Terraffic Pty Ltd

27th May 2022
Ref 22021

**LAND AND ENVIRONMENT COURT PROCEEDINGS 2021/295821
PROPOSED CHILD CARE CENTRE - 4-8 ELIZA PLACE, PICTON
RESPONSE TO TRAFFIC AND PARKING RELATED CONTENTIONS**

Modification
to median island

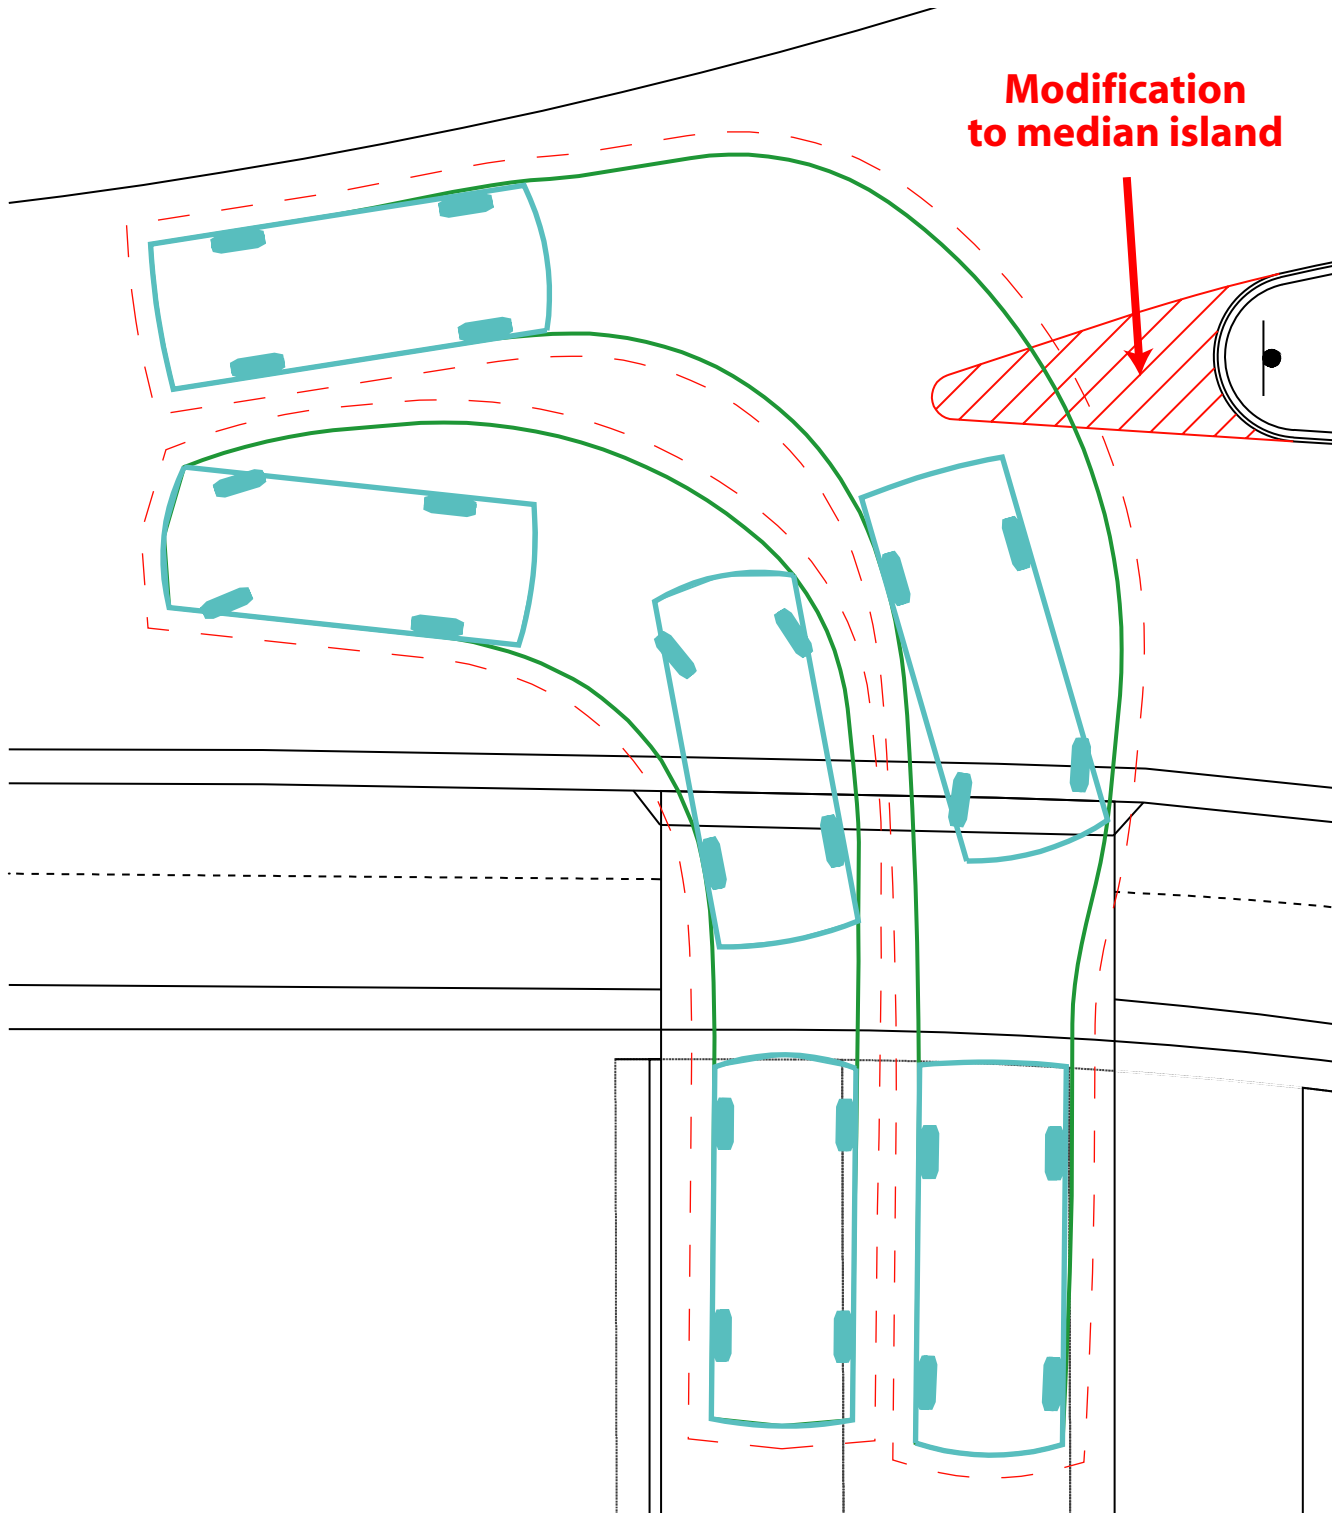
- b) *The proposed vehicular access driveway requires modifications to the existing concrete median within Eliza Place to facilitate compliant simultaneous swept path needs of opposing B99 / B85 Design Cars in accordance with AS2890.1:2004. Any modifications to the existing median and road pavement (noting the level difference in the road pavement on either side of the median) will require the approval of Council and its Local Traffic Committee.*

Consulting engineers D&M Consulting have been engaged to undertake the civil engineering works for the proposed development. Drawing Number 200774 is reproduced in Appendix E showing a modification to the centre median island to facilitate concurrent entry and exit of vehicles accessing the proposed development.

The swept path of the B99 vehicle entering and B85 exiting the development site concurrently is also reproduced in Appendix E confirming that the modification to the median island is clearly satisfactory.

TURNING PATHS PLAN

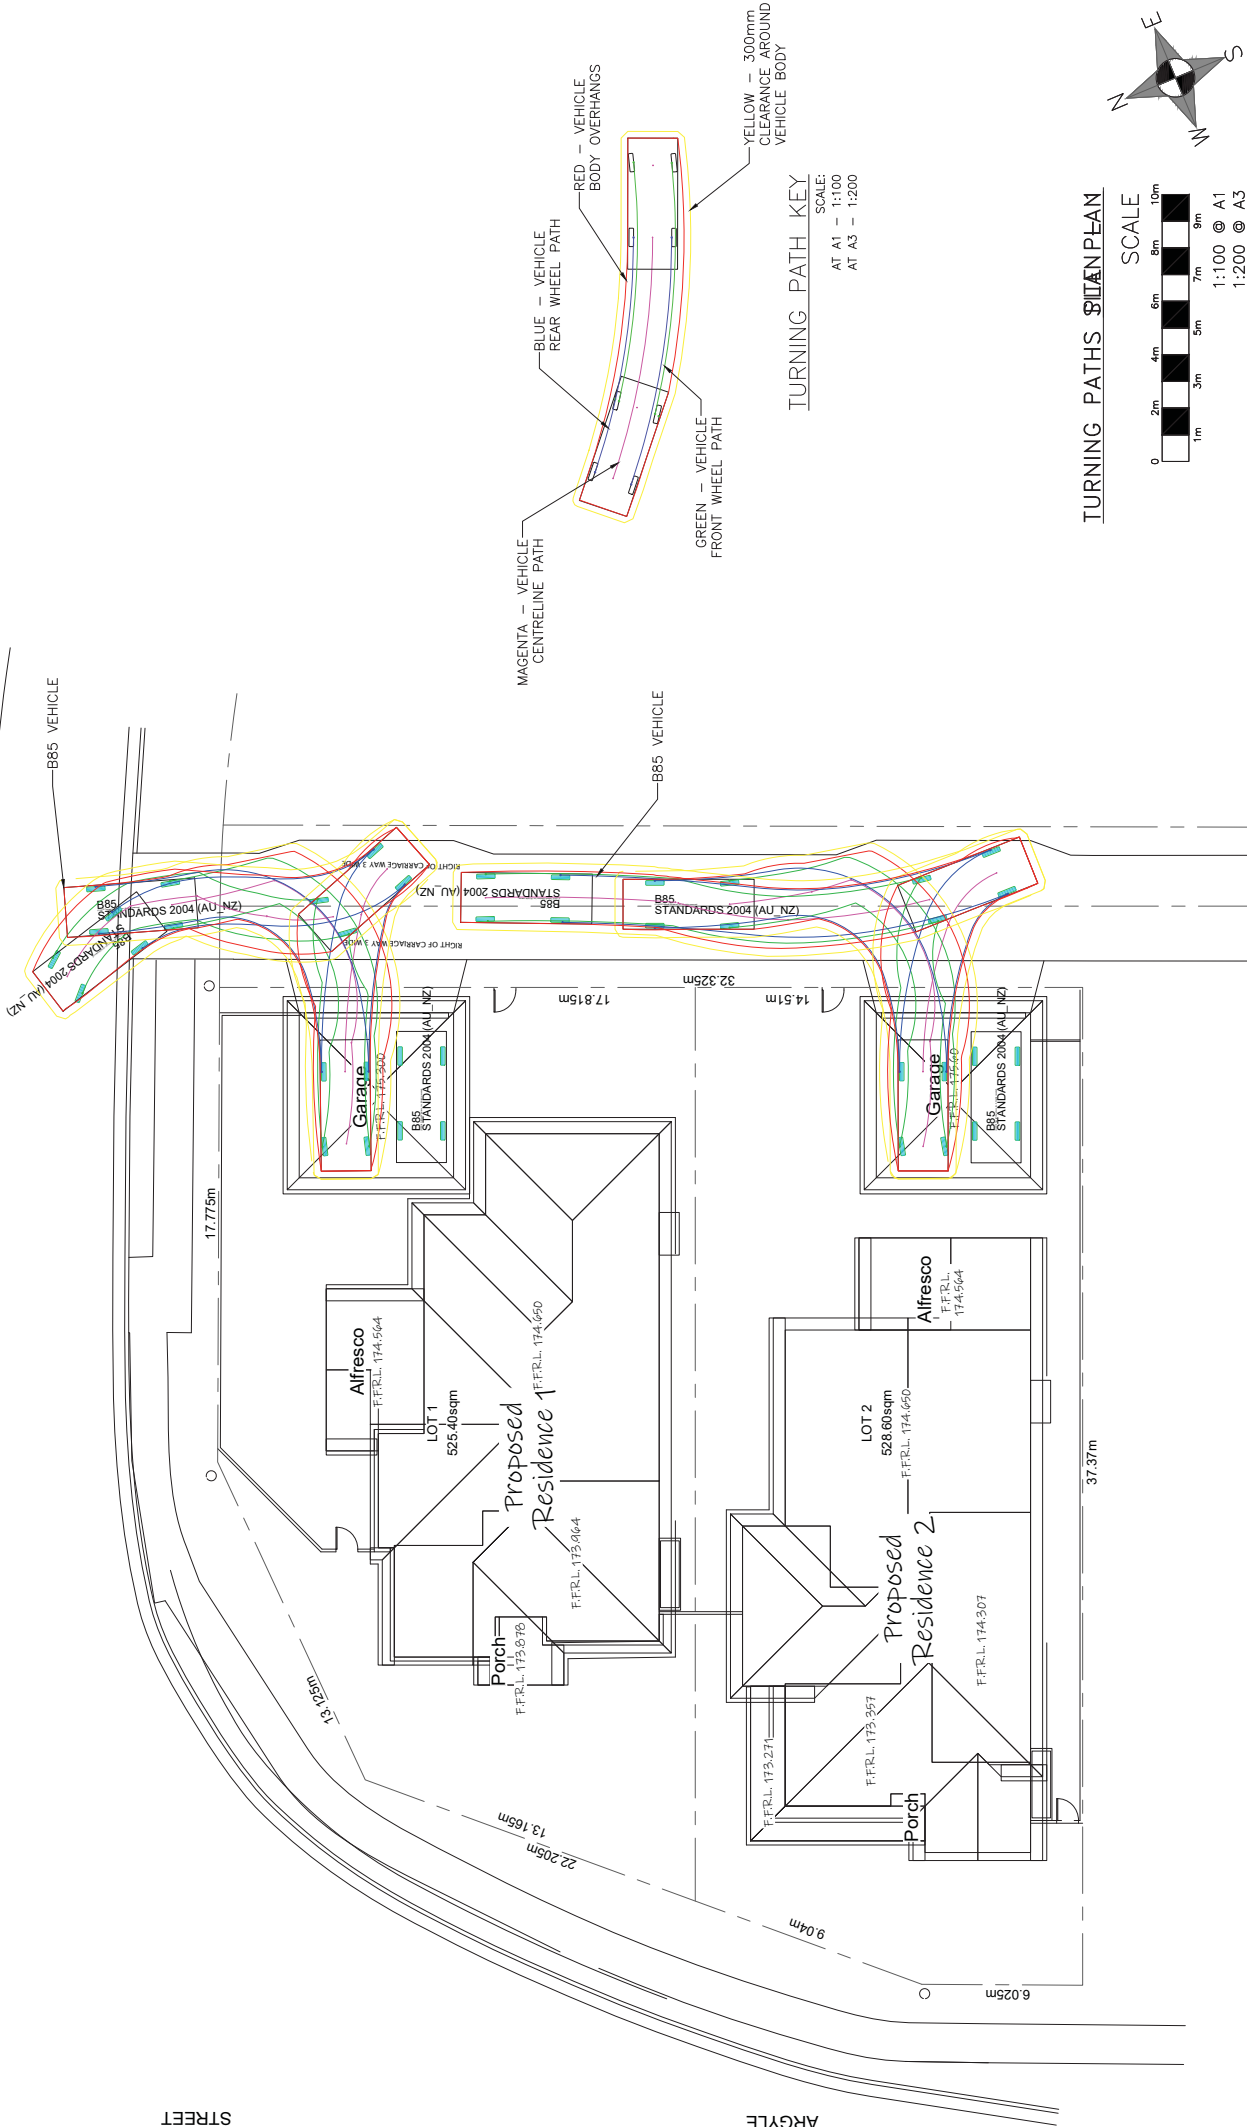
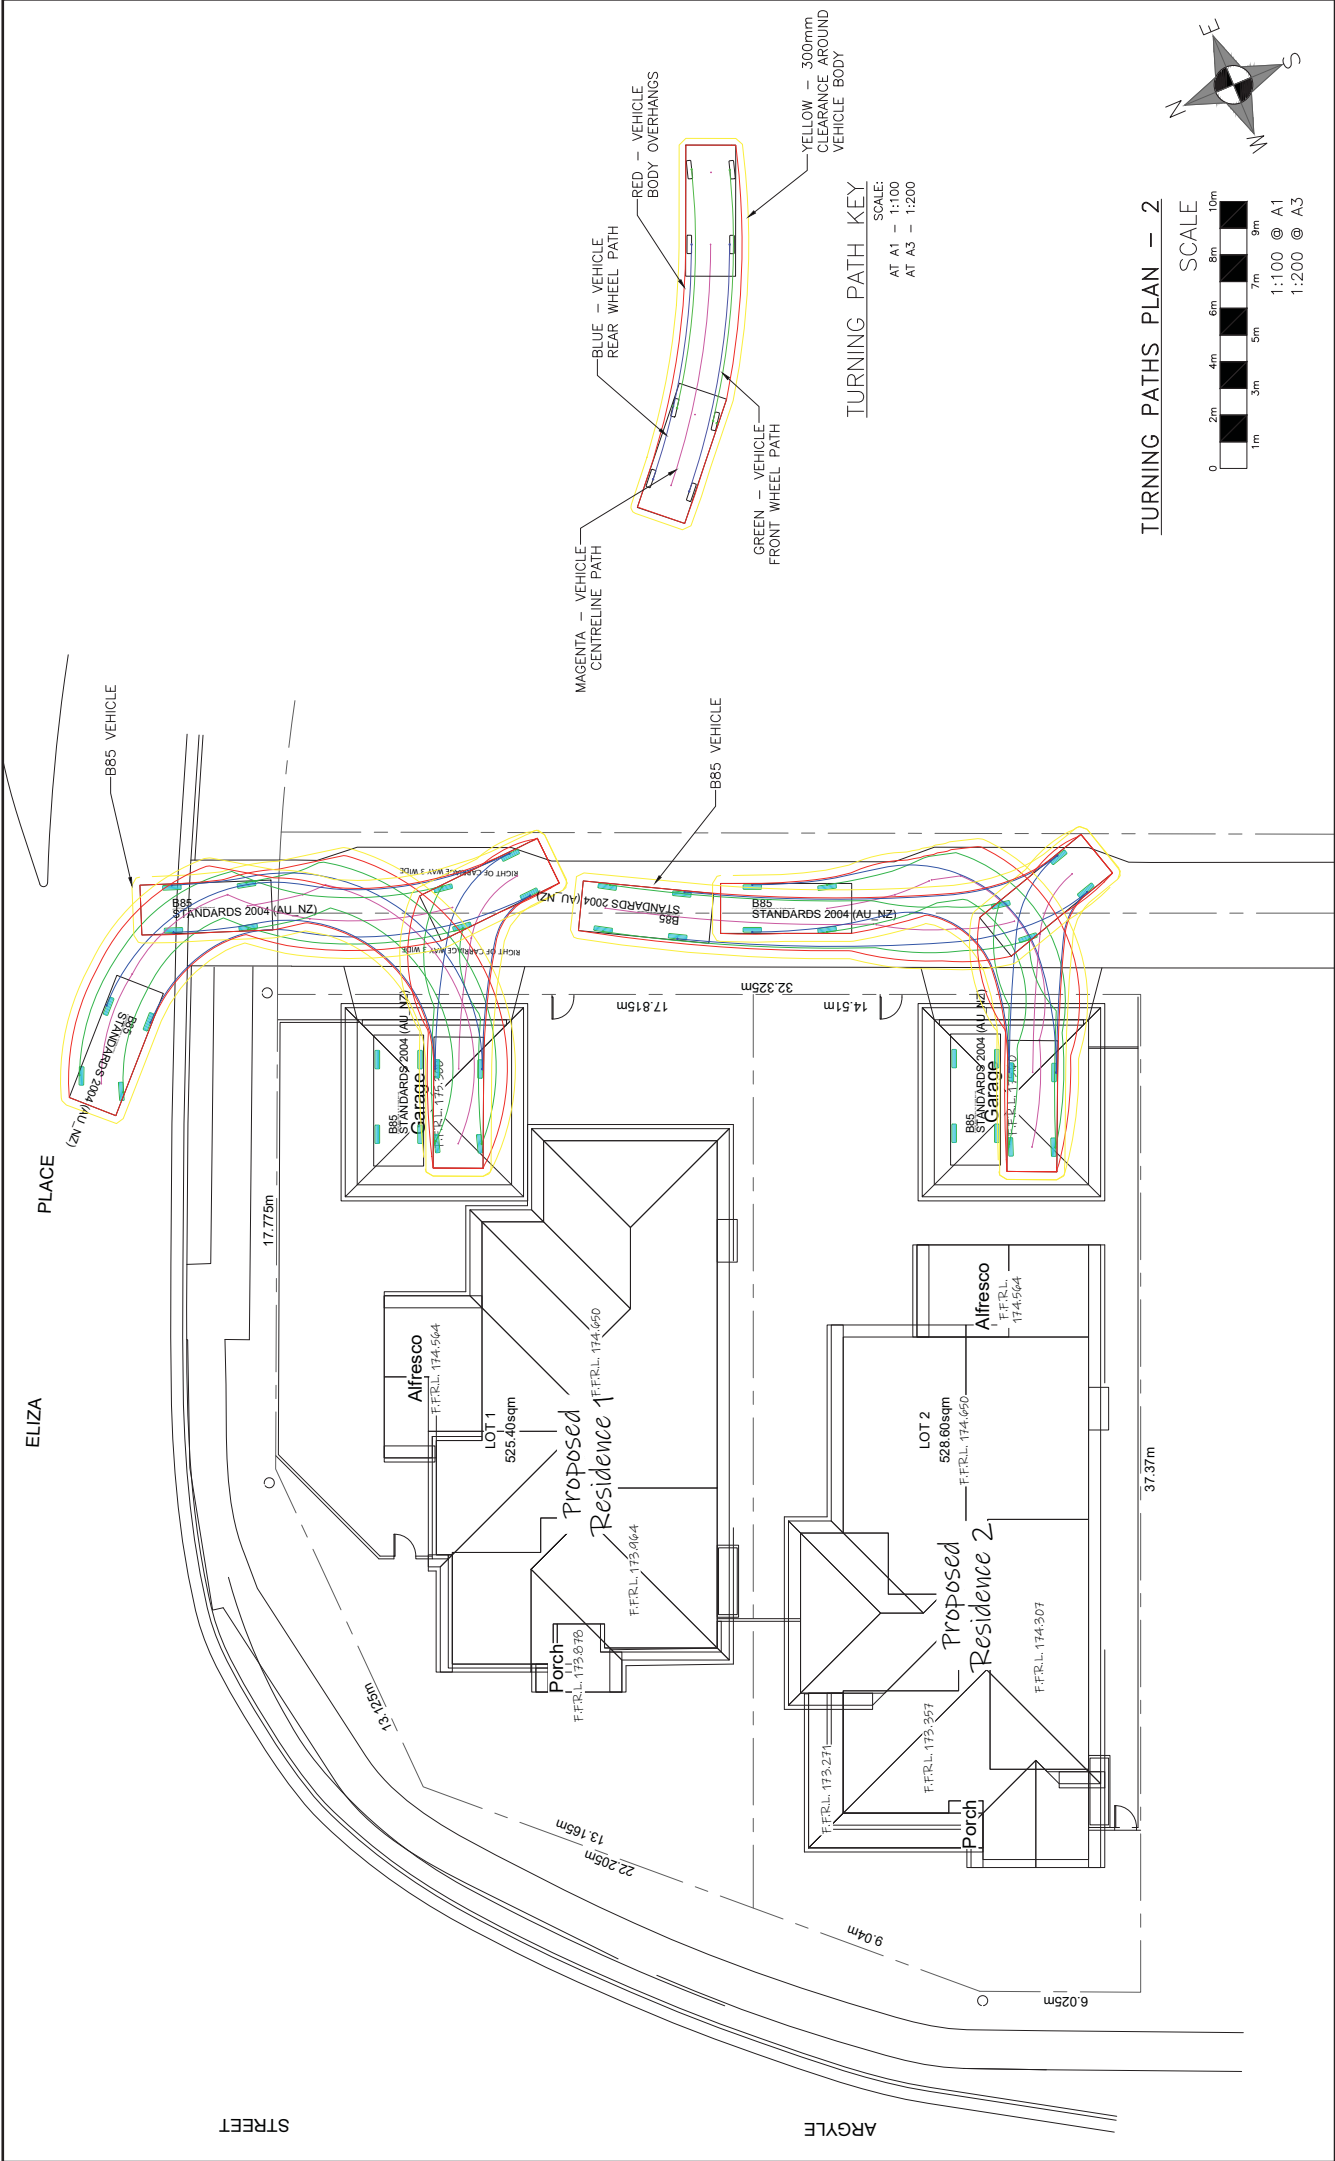
- c) *The development site incorporates Lots 502 and 503 in DP 1201968 plus Lot 506 in DP 1201969. There is a restriction on the use of the land for the adjacent Lot 504 in DP 1201968 that prohibits direct vehicular access for Lot 504 from either Argyle Street or Eliza Place which must utilise rights of carriageway over Lots 502 and 503 for purposes of vehicular access.*

- f) *A vehicular access point for Lot 504 could reasonably be located towards the rear of that lot that which would create conflicts with pedestrians at the proposed zebra crossing that is shown at the southern end of the Lot 503 access handle.*

Consulting engineers D&M Consulting have been engaged to undertake the civil engineering works for the proposed residential dwellings on Lot 504 that will gain vehicular access from the Right of carriageway. Plans of this proposal including B85 vehicle swept paths are reproduced in Appendix F. It may be necessary for the swept paths to be updated on the latest ROW design.

The swept paths prepared by D&M Consulting do not indicate that vehicles accessing Residence 2 will create a conflict with the pedestrian crossing on the subject site.
